**DEVELOPMENT PERMIT STAFF COMMITTEE MEMBERS**

**EXECUTIVE SUMMARY**

**DEVELOPMENT PERMIT STAFF COMMITTEE RECOMMENDATION: APPROVE**

THAT the Board APPROVE Development Application No. DP-2019-00680 submitted, the plans and information forming a part thereof, thereby permitting the development of an 11 storey mixed-use building containing 111 dwelling units (social housing), a healing centre, food centre, and a long house gathering space (social service centre), all over 2 levels of underground parking having vehicular access from the lane, subject to the following conditions:

Figure 1: Context Map

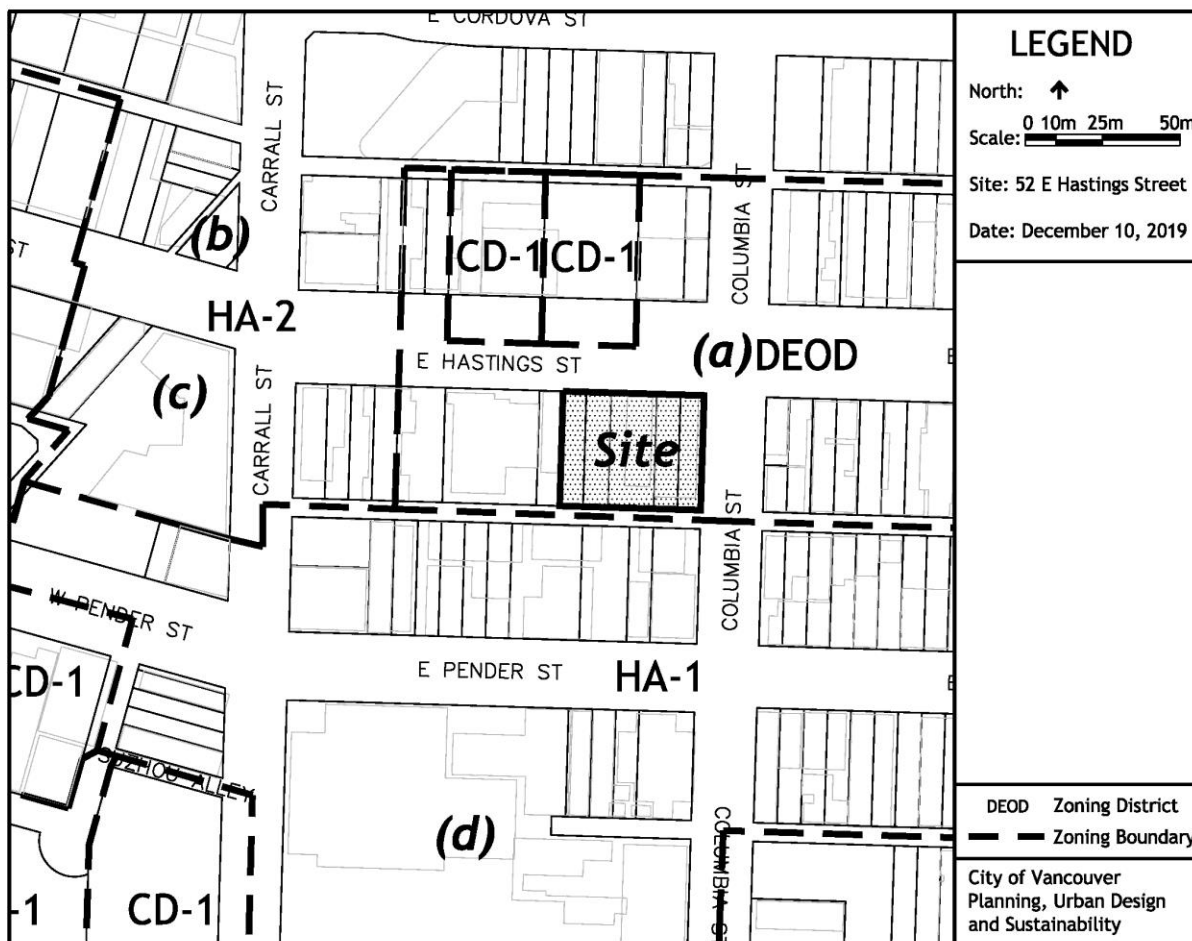
- **Context:** Significant adjacent development is shown in Figure 1, and includes:
  - a) **DEOD Zones:** Generally, DEOD sites permit 5.0 FSR and a 100 ft. height. On corner sites, 7.0 FSR and 120 ft. can be considered
